AERONAUTICAL CHARTING MEETING
Charting Group
Meeting – April 27 - 29, 2021

RECOMMENDATION DOCUMENT

FAA Control #21-01-359

Subject: Chart Supplement Visual Departures & Noise Abatement Procedures

- KSFO - Noise Abatement Procedures

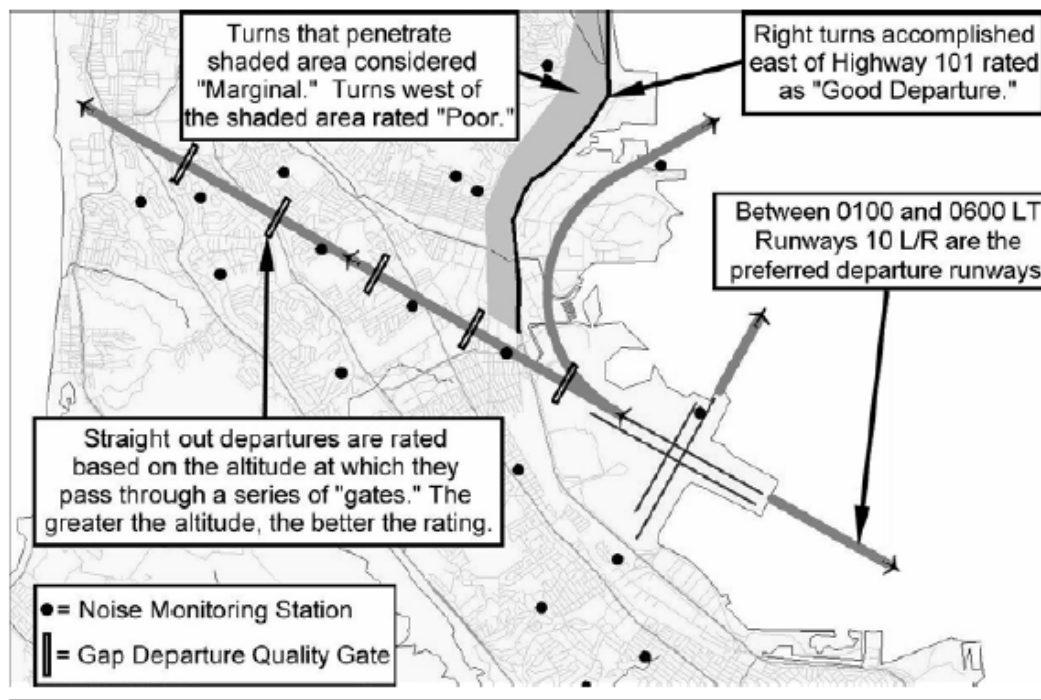
Also, the quality of these graphics is not very good and does not lend itself well for digital representation in Garmin's electronic flight bag (EFB) applications and portables.

2. Increase the quality of the images for better display in Garmin's electronic flight bags (EFBs) and portables

Valerie Watson, FAA/AJV-A250, said these procedures will have to remain in the Chart Supplement. She said the work being done by the Chart Supplement team to apply XML tags to Supplement content will help make these procedures more accessible. With regard to the image quality, she said this will be difficult to accomplish because the graphics are submitted to Aeronautical Information Services camera-ready. Joshua agreed that XML tagging will be a big help.
